# City of Corpus Christi

### Planning Commission

Wednesday, June 11, 2025

**TECHNICAL REVIEW PLAT REQUIREMENTS  
REGULAR PLANNING COMMISSION MEETING**

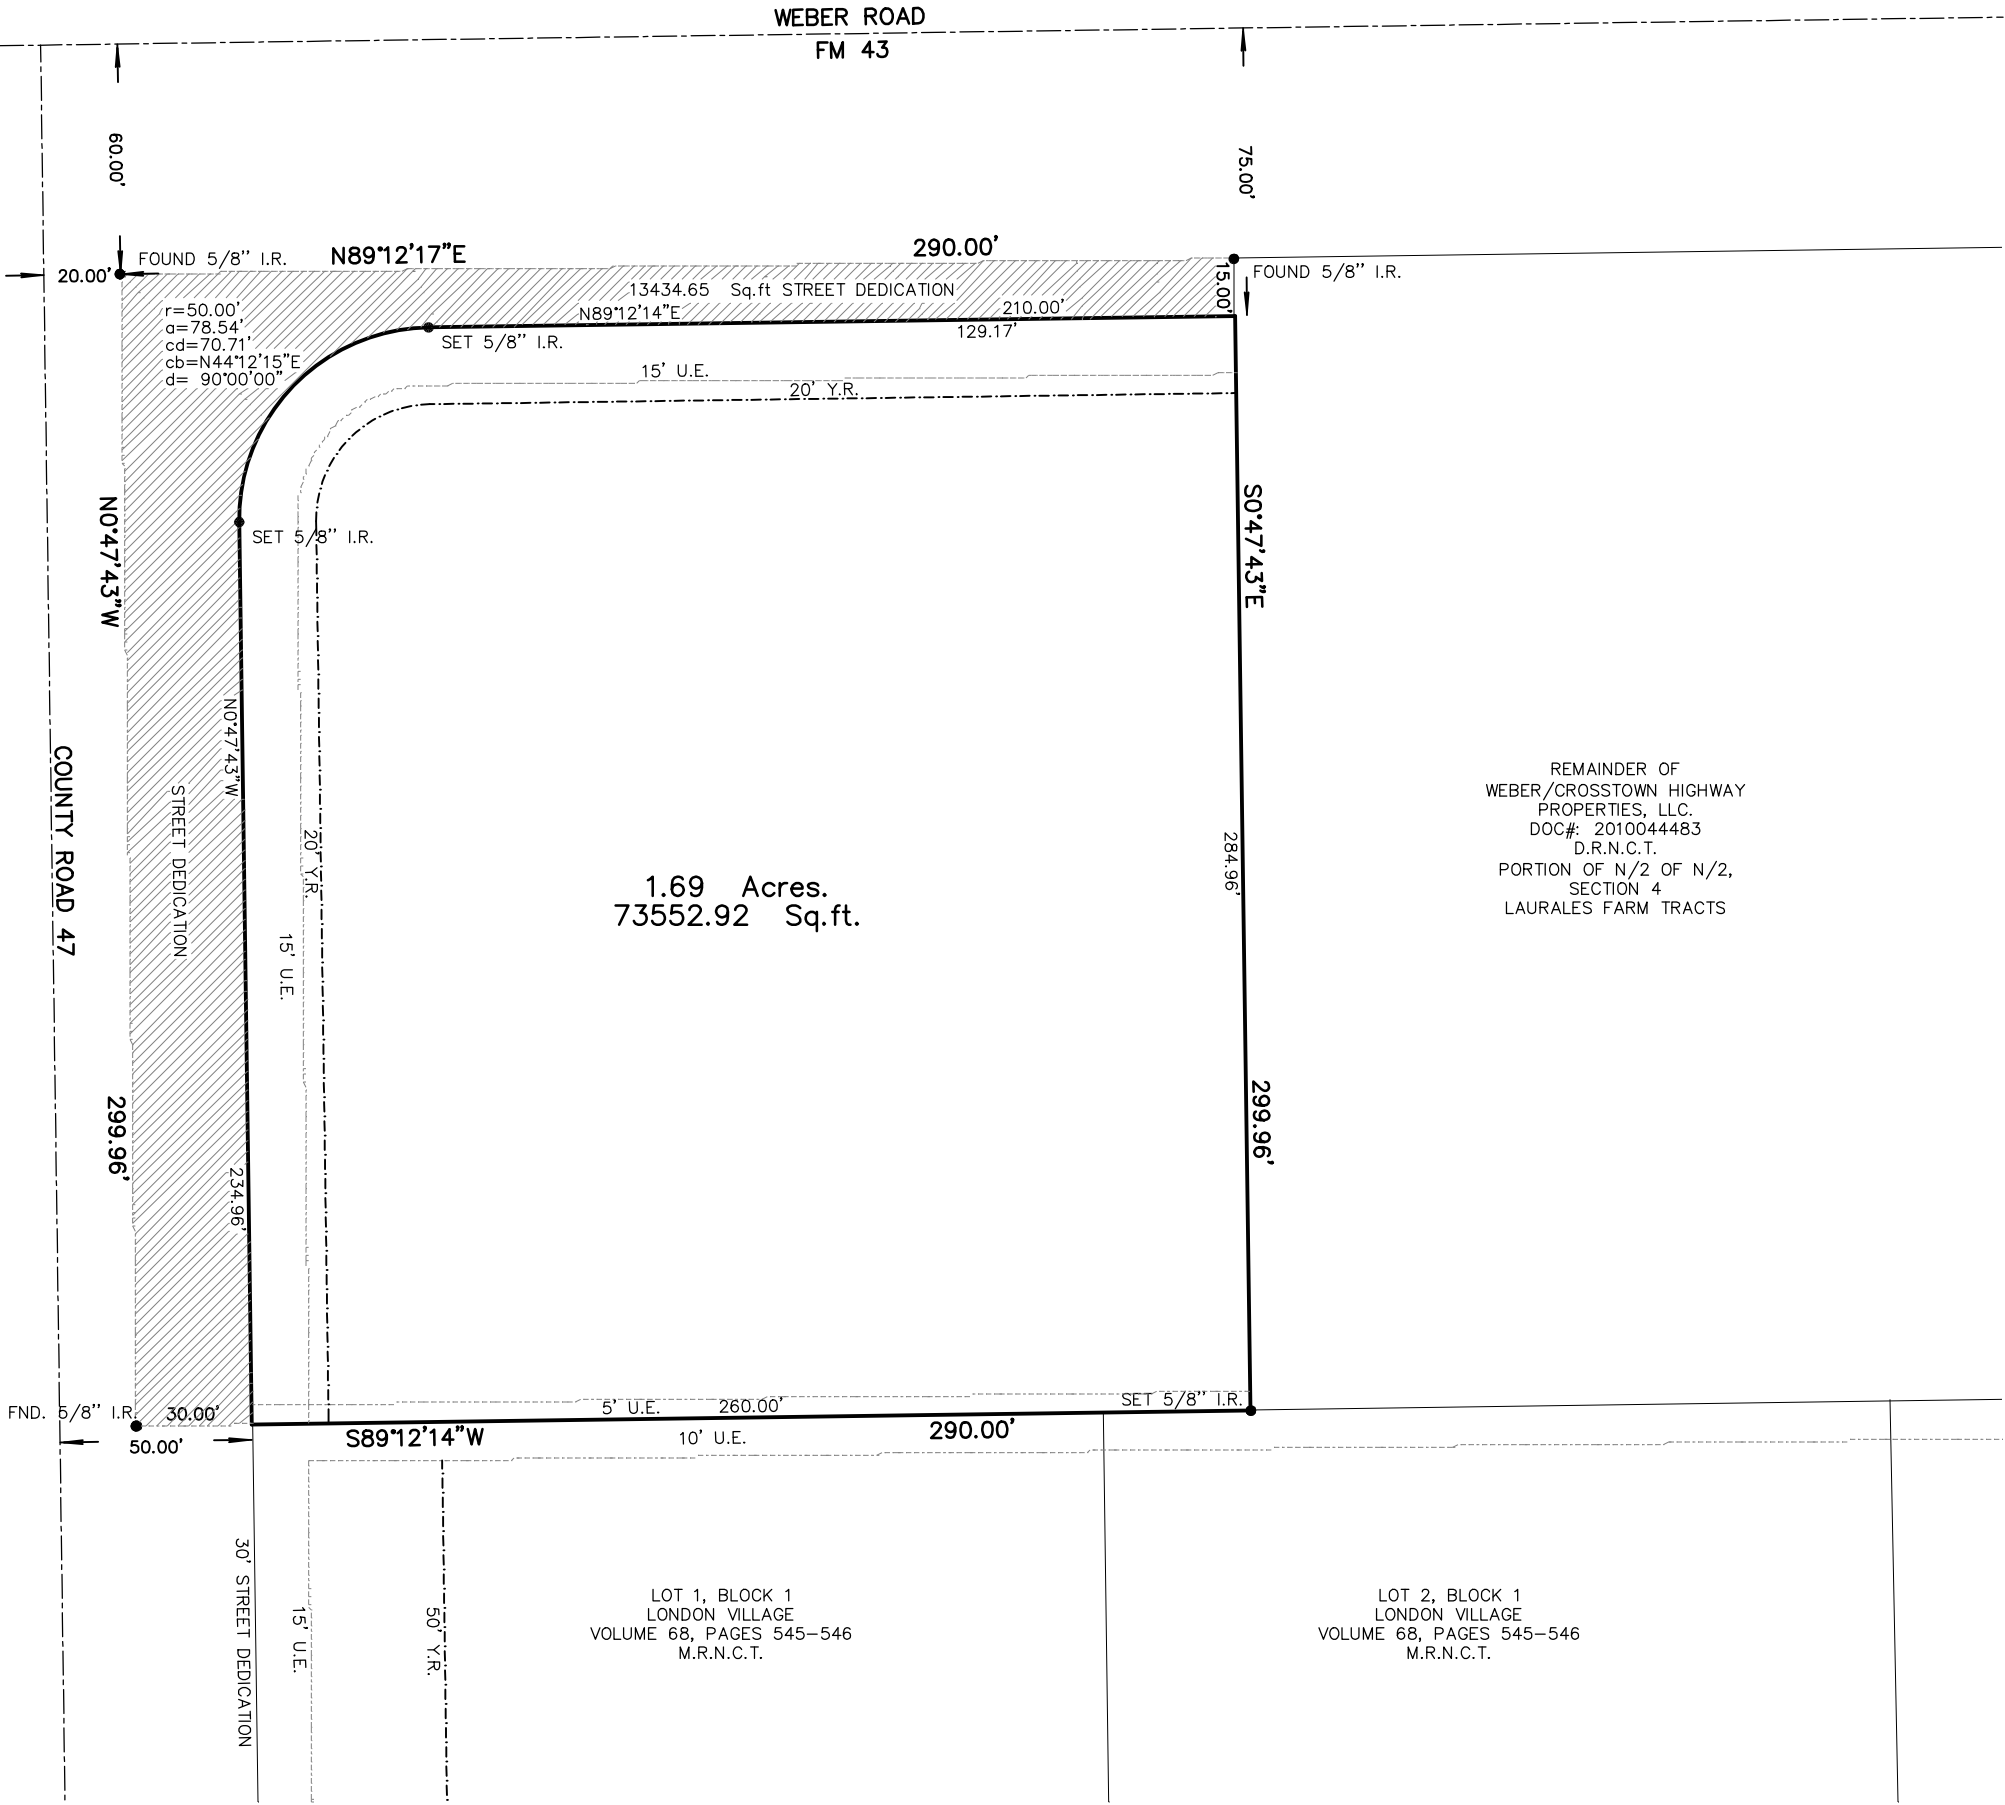
Comment ID	Page Reference	Annotation Type	Author : Department	Status	Review Comments	Applicant Response Comments
8	P001	Note	Bria Whitmire : DS	Closed	Improvements Required for Recordation, per UDC 8.1.4: A. Streets: no Sidewalks: no B. Water: no Fire hydrants: yes, upon development C. Wastewater: no (septic) D. Stormwater: no E. Public open space: no F. Permanent monument markers: no Please note, improvements required should be constructed to city standards, found in Article 8 and the IDM.	
10	P001	Note	Bria Whitmire : DS	Closed	Remove note 8 as property has now been annexed. (Will need to submit tap application form and meter sizing form upon development.)	
11	P001	Note	Bria Whitmire : DS	Closed	Update year shown on Nueces County Health stamp from 2022 to 2025.	
2	P001	Note	Mark Zans : LD	Closed	Plat is a final plat. PC approval will be needed.	
3	P001	Note	Mark Zans : LD	Closed	This plat is on the 30-day tract for approval, approval with Conditions, or disapproval by 5/28/25 The deadline for revisions to be submitted is 5/19/25.

4	P001	Note	Mark Zans : LD	Closed	The plat will be recommended as Conditional Approval for Resolution comments received and that have remained Open and unmet.	
5	P001	Note	Mark Zans : LD	Closed	A request or response may be made for an additional 30 days for Public Notice plat with a Waiver or to resolve Open comments. This request must be made directly to Development Services within the 30-day initial period.	
7	P001	Callout	Mark Zans : LD	Closed	Change Al Raymond name to Michael Dice.	
15	P001	Note	Mark Zans : LD	Closed	Fire comments 1-10  1PlatNote: All code reference is based on currently adopted International Fire Code (IFC) 2021 and Corpus Christi Water Distribution Standards. 2Plat"Commercial Development shall have a fire flow of 1,500 GPM with 20 psi residual Fire hydrant every 300 feet and operational." 3Plat507.5.1 (amendment) Where Required: All premises, other than one-family detached dwellings, where buildings or portions of buildings are located more than 150 feet from a fire hydrant shall be provided with approved on-site hydrants

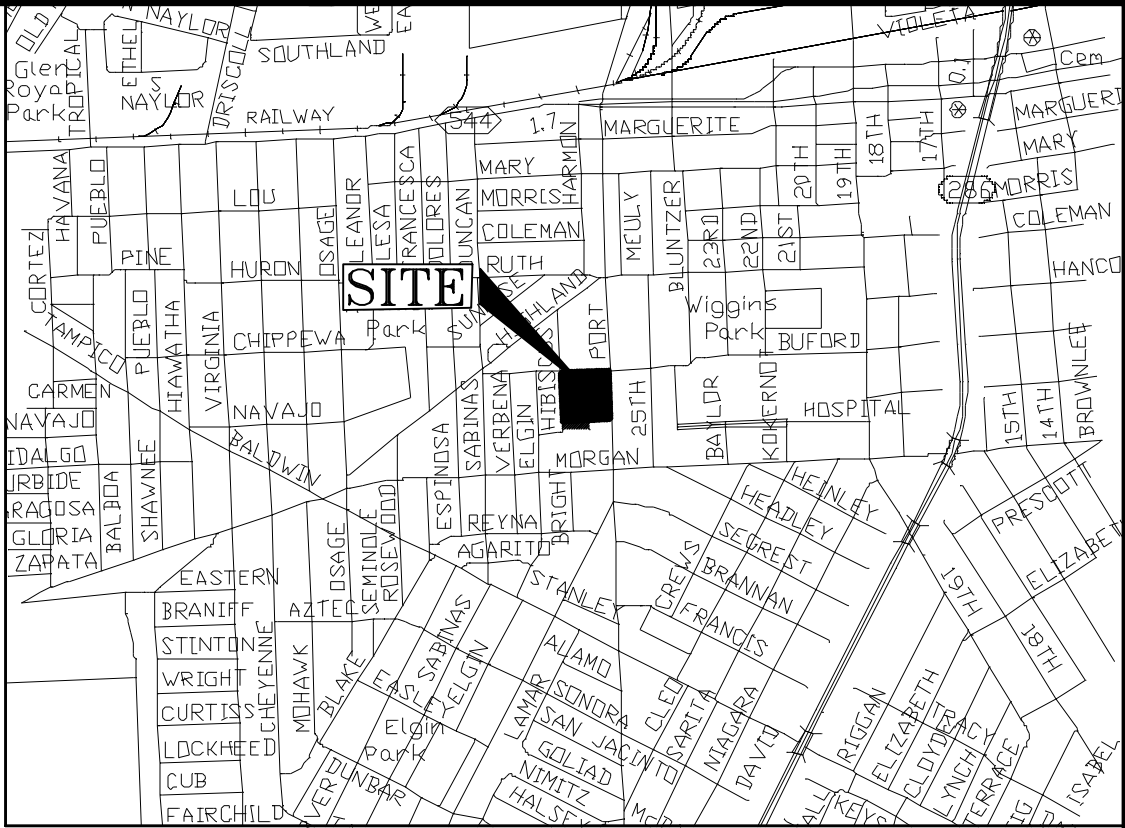
Comment ID	Author : Department	Status	Review Comments	Applicant Response Comments
11	Alex Harmon : DS	Closed	Improvements Required for Recordation, per UDC 8.1.4. A. Streets: No Sidewalks: No B. Water: No Fire hydrants: No, however, may be needed at site development C. Wastewater: No D. Stormwater: No E. Public open space: No F. Permanent monument markers: No  Please note, improvements required should be constructed to city standards, found in Article 8 and the IDM.

Comment ID	Page Reference	Annotation Type	Author : Department	Status	Review Comments	Applicant Response Comments
7	P002	Callout	Mark Zans : LD	Closed	Depict water line along Hibiscus Street.	
12	P002	Note	John Gonzales : WW	Closed	Wastewater construction is not required for platting (UDC 1.2.1.D & 8.2.7; Wastewater Collection System Standards).	
13	P002	Note	John Gonzales : WW	Closed	Water construction is not required for platting (UDC 1.2.1.D & 8.2.6; Water Distribution Standards).
